NOTICE OF DECISION

CLASS 3 SITE PLAN REVIEW / CLASS 2 ADJUSTMENT / CLASS 2 DRIVEWAY APPROACH PERMIT CASE NO.: SPR-ADJ-DAP22-25

SUMMARY: A consolidated application for development of three new industrial buildings in Mill Creek Corporate Center.

IN THE MATTER OF APPROVAL OF	)	FINDINGS AND ORDER
CLASS 3 SITE PLAN REVIEW,	)	
CLASS 2 ADJUSTMENT, AND CLASS 2	)	
DRIVEWAY APPROACH PERMIT	)	
CASE NO. SPR-ADJ-DAP22-25	)	
4600 BLOCK OF TRUAX DR SE	)	JUNE 24, 2022

PACTRUST - MCCC TRUAX PROPERTY
TRUAX DRIVE ONSITE DEVELOPMENT PLANS
OVERALL DEVELOPMENT PLAN

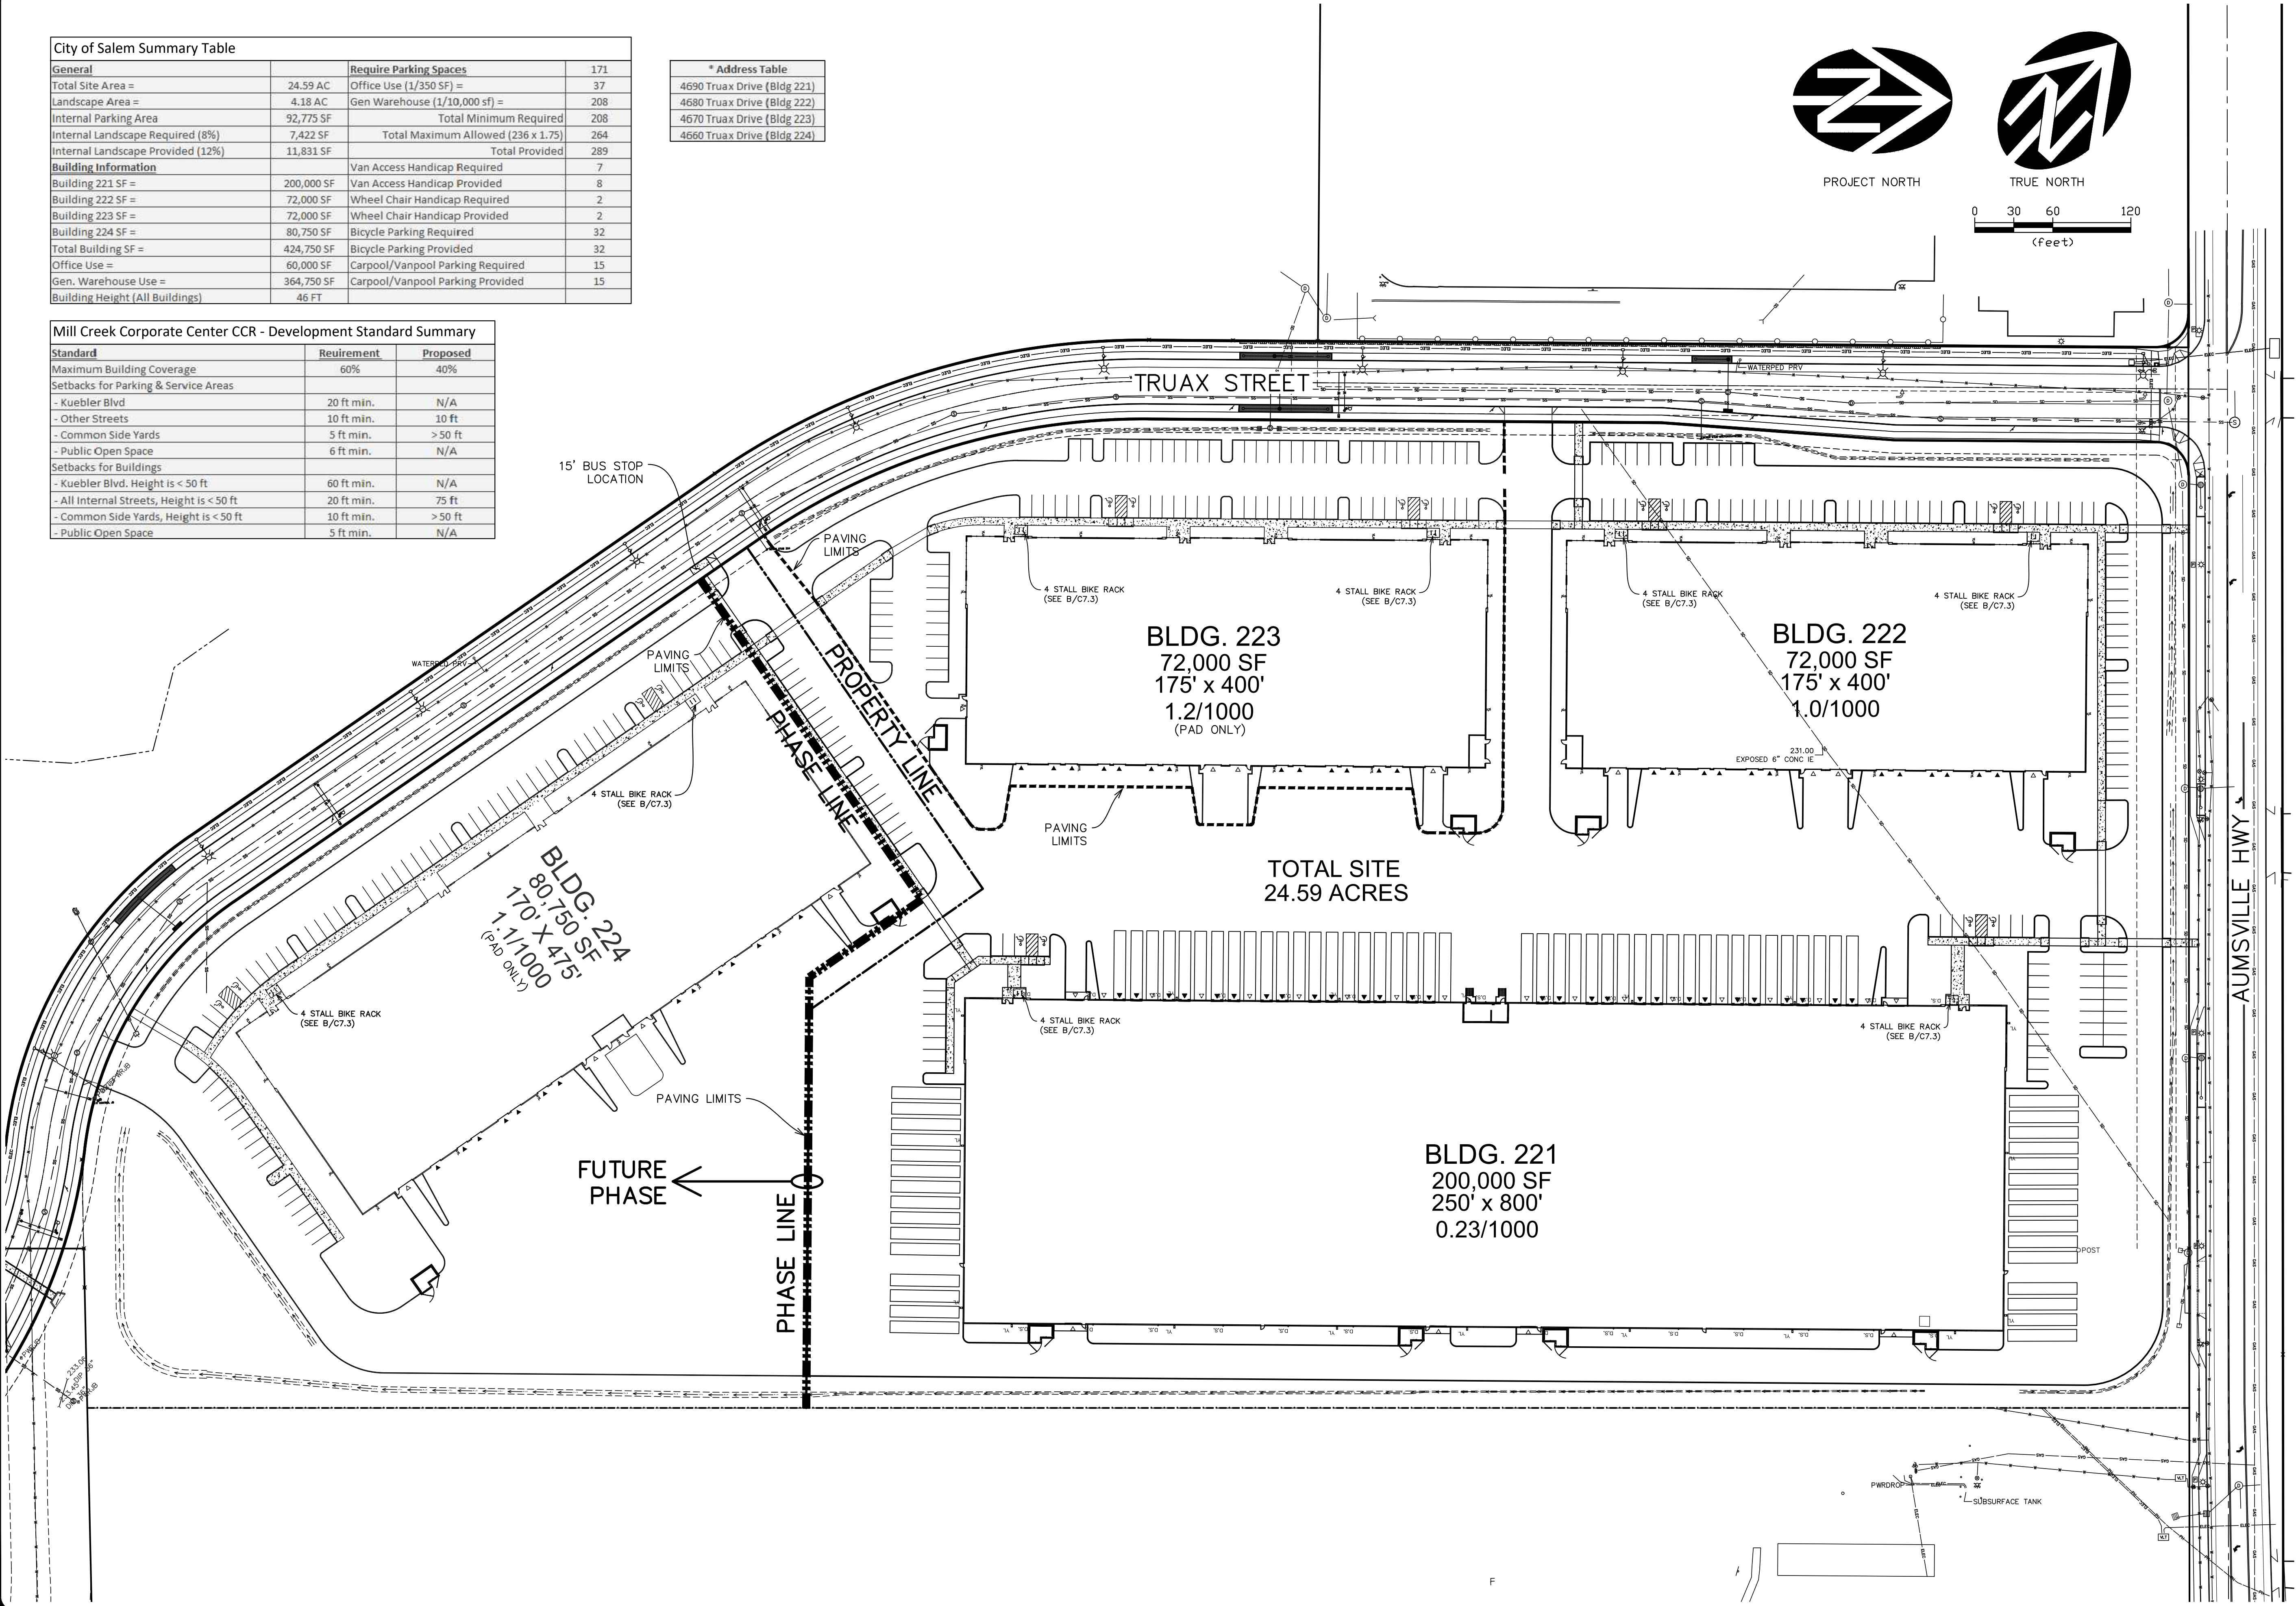
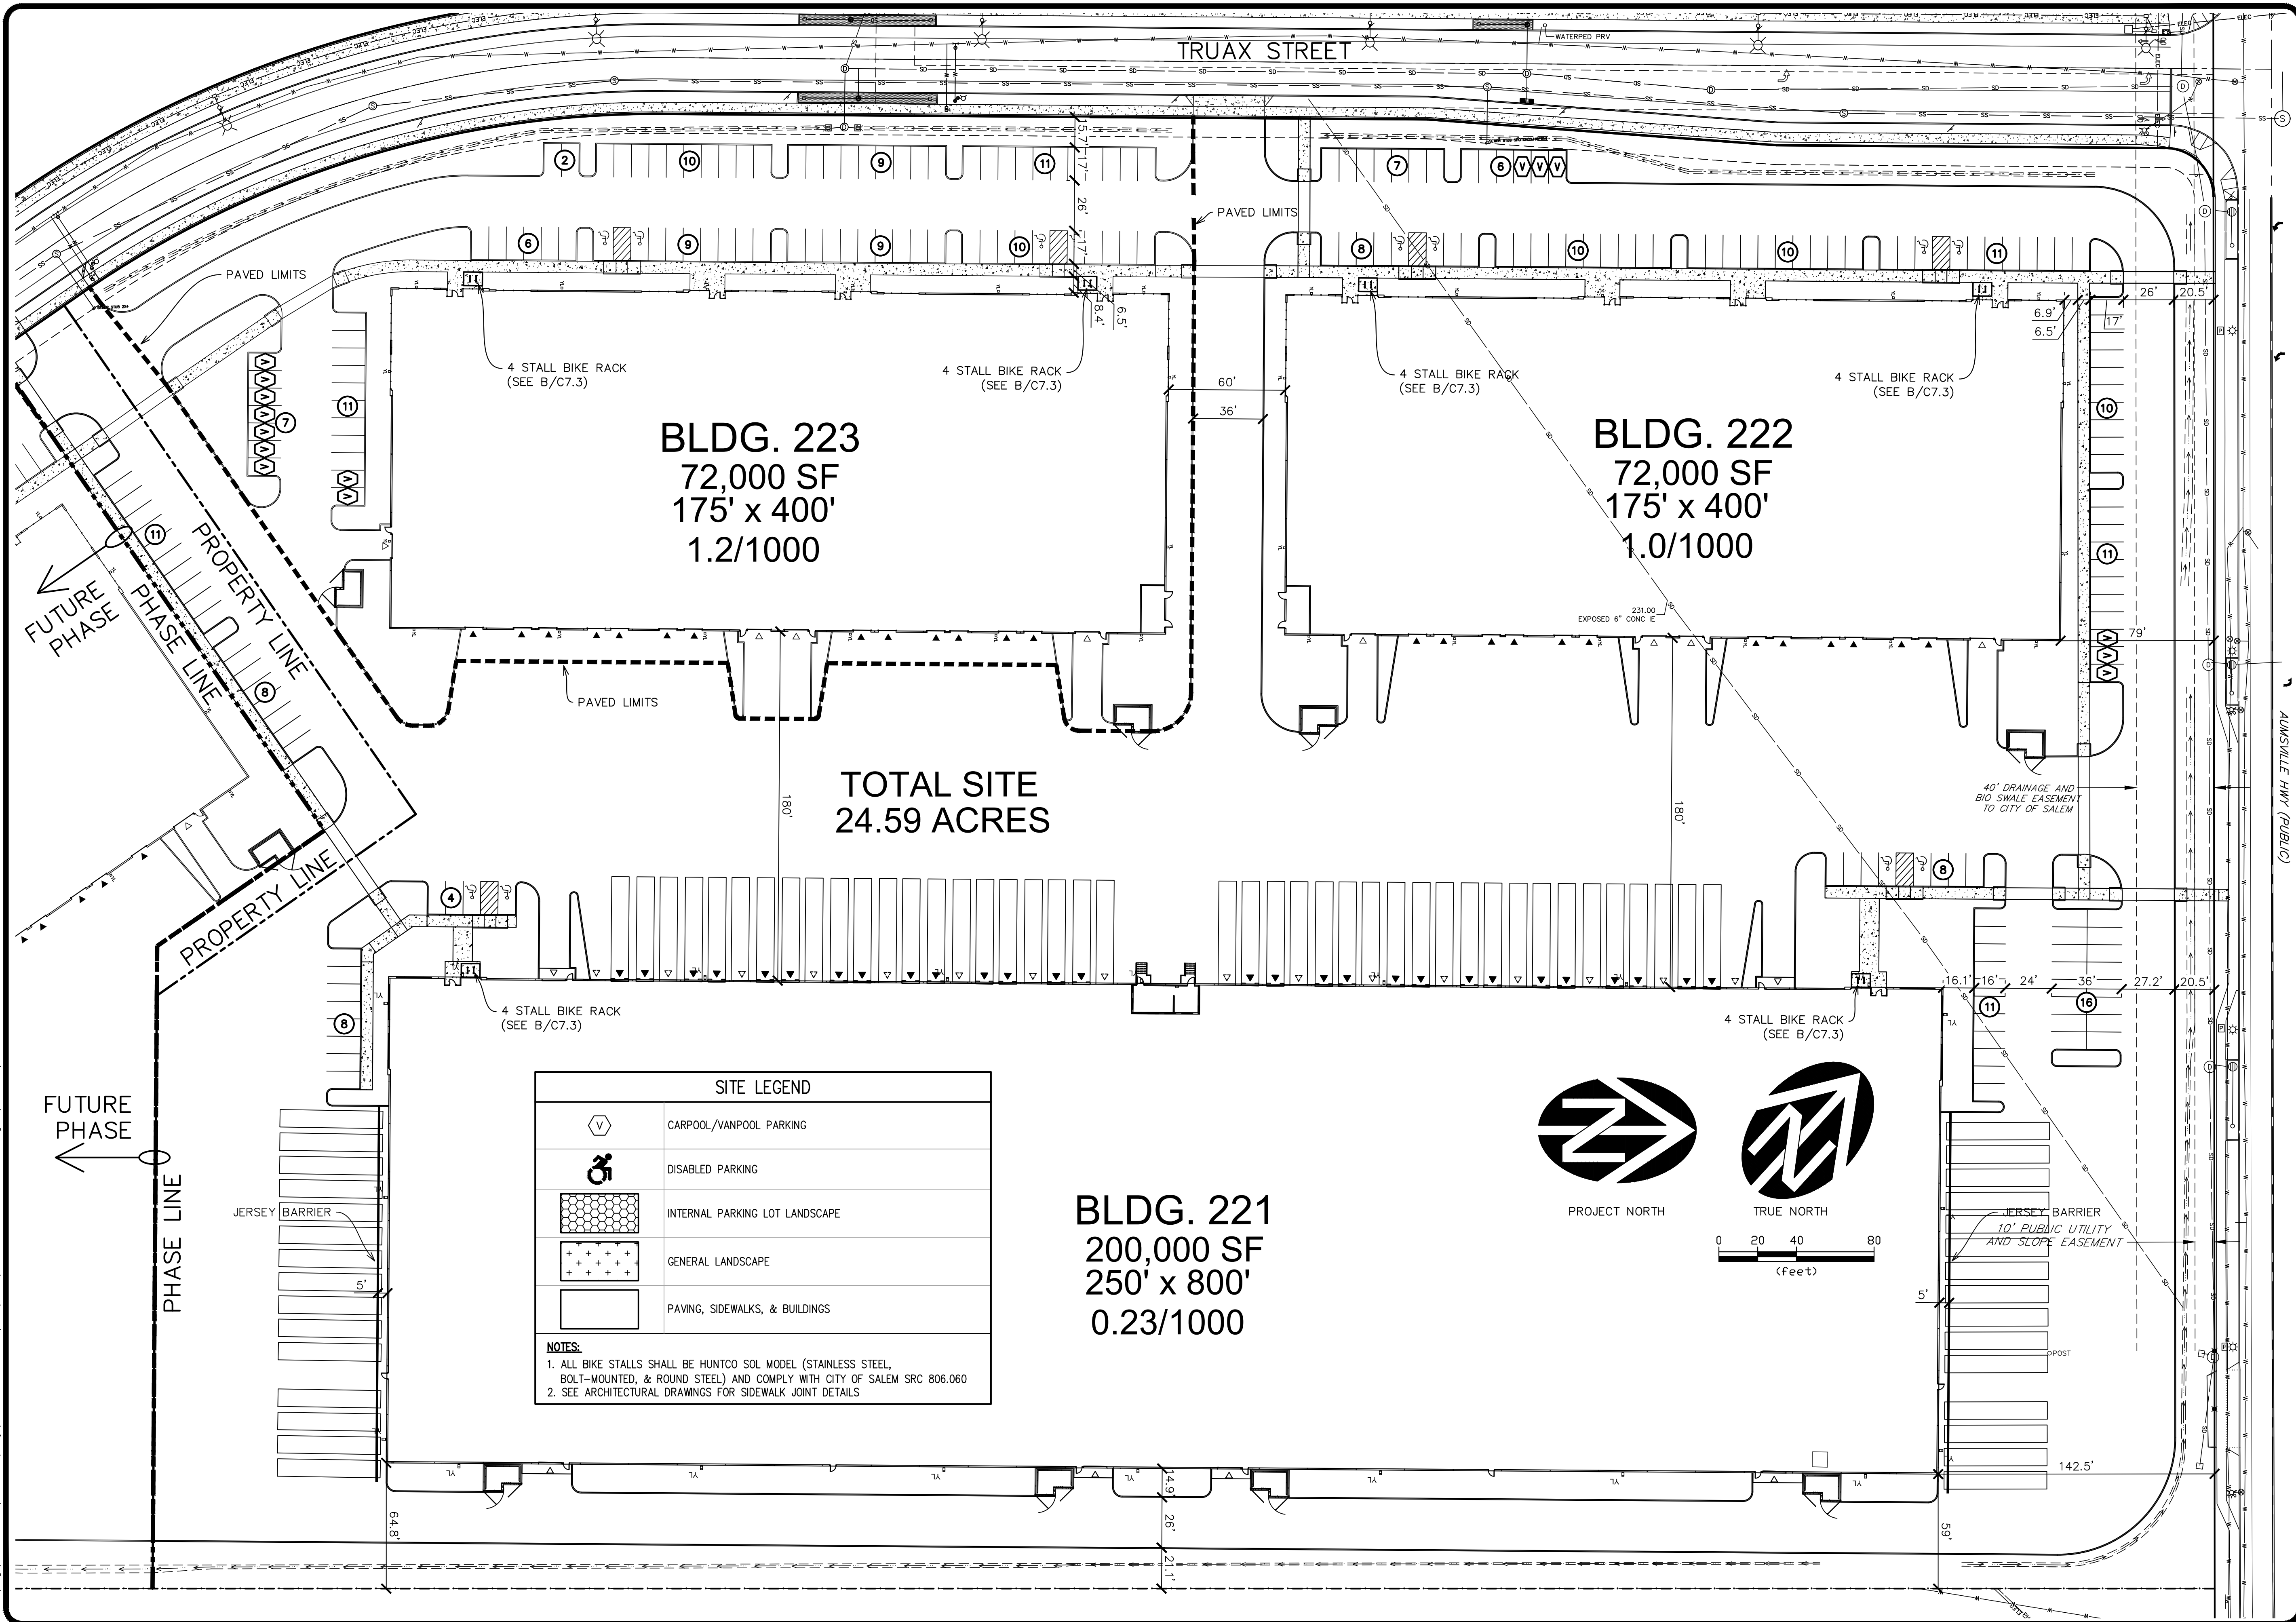
Finding: Three buildings are proposed with this phase of development; in addition, the proposed development is connected and part of the same development site as a future phase with an additional building to the west. The proposed site plan indicates that pedestrian connections are provided between the primary entrances of each proposed building connecting to future pedestrian pathways on the abutting development site to the west, meeting the standards of this section.

The proposed site plan indicates that 289 parking spaces will be provided on site, 15 carpool/vanpool parking spaces are indicated on the site plan, and no compact spaces are proposed. However, most parking spaces measure 17 feet in length, where two feet may overhang, provided they do not project into a required pedestrian connection. As such, the following condition applies:

Condition 5: At the time of building permit, the applicant shall designate all 17-foot-long parking spaces abutting a pedestrian connection as compact spaces and provide bumper guards or wheel barriers, or the applicant shall move the five-foot-wide pedestrian connections two feet away from all parking spaces that are 17 feet in length.

1 TRASH ENCLOSURE
1/4" = 1'-0"

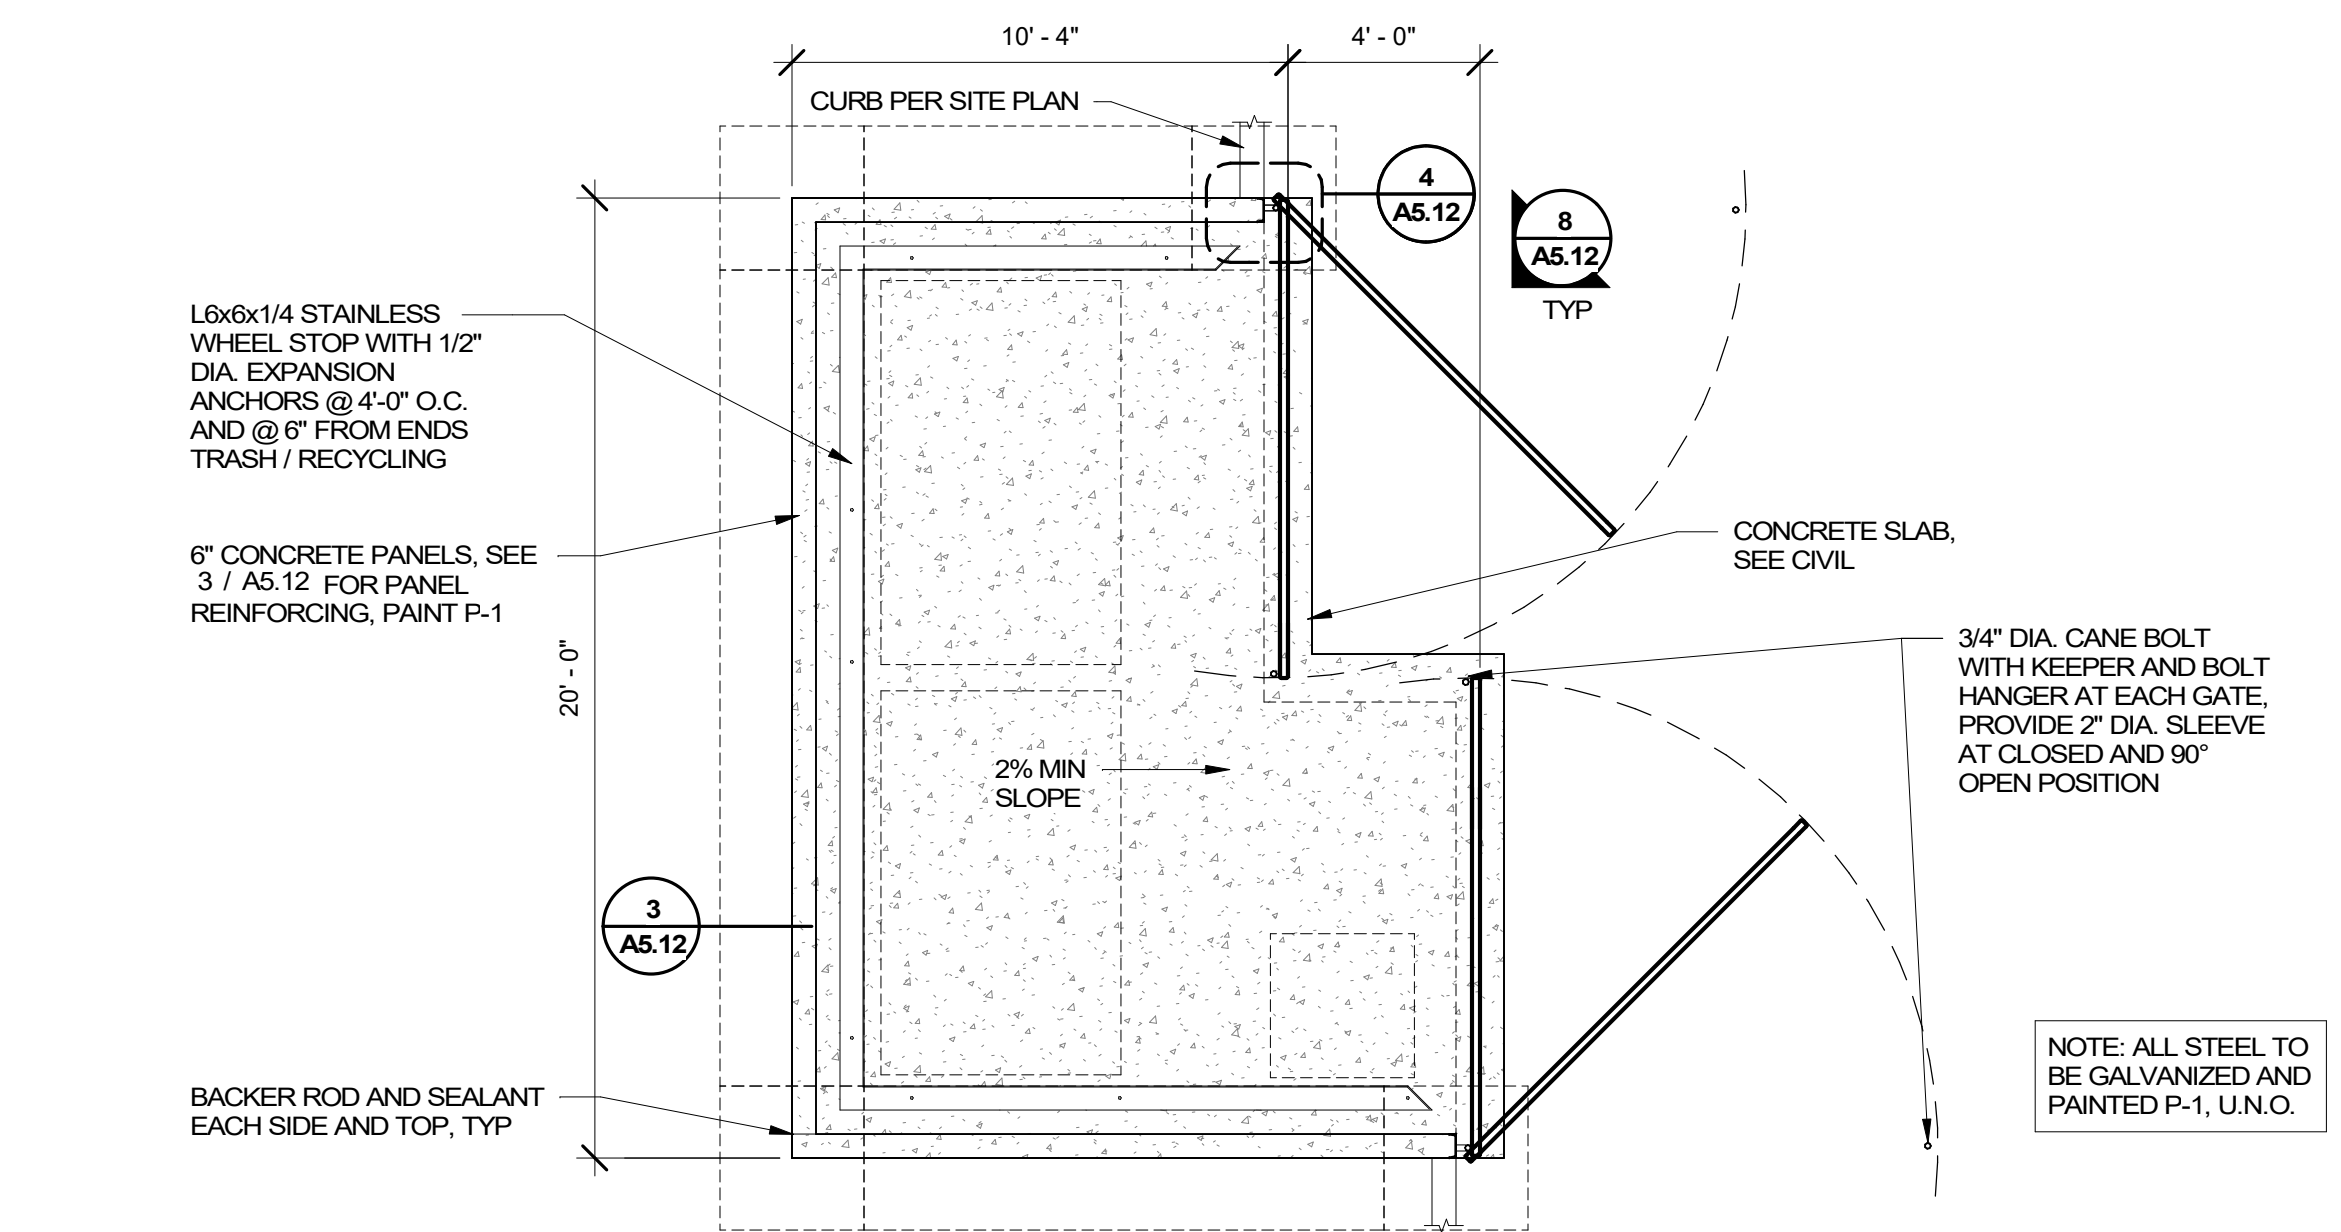
Finding: The proposed plans do not indicate the pad area surrounding the trash enclosures. To ensure compliance, the following condition applies:

Finding: The trash enclosure plans indicate that a wheel stop is provided 12 inches inside the perimeter of the enclosure walls to prevent damage from receptacle impacts consistent with this standard.

- Condition 3:** At the time of building permit, the applicant shall indicate surrounding pad areas for all trash enclosures, pursuant to SRC 800.055(b)(1).
